Access Compliance Report Public Rights-of-Way (Curb Ramps)

Intersection ID: N/A Main Street: YORK_CENTER **Cross Street: N/A** Location: NW Initial Pass/Fail: Fail ADA ID: C2EE455B918C Ramp Type: PerpDiag **Overall Compliance: No Severity Score:** 12.5

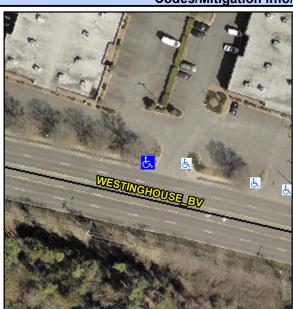
Not Found, R304.5.3

| Field Measurements/Component Compliance | | | | | | |
|---|-----------------------|------|------------|--------------------|-------------------------|------|
| Yes | Ramp Width (in) | 50.0 | No | Ramp XSlope (%) | | 6.4 |

E WESTINGHOUSE BV Street 1 Name Stop Condition-Street 2 None Street 2 Name **ENTRANCE** Stop Condition-Street 1 None Remove & Replace Curb Ramp With **Two New Directional Ramps or** Equivalent.
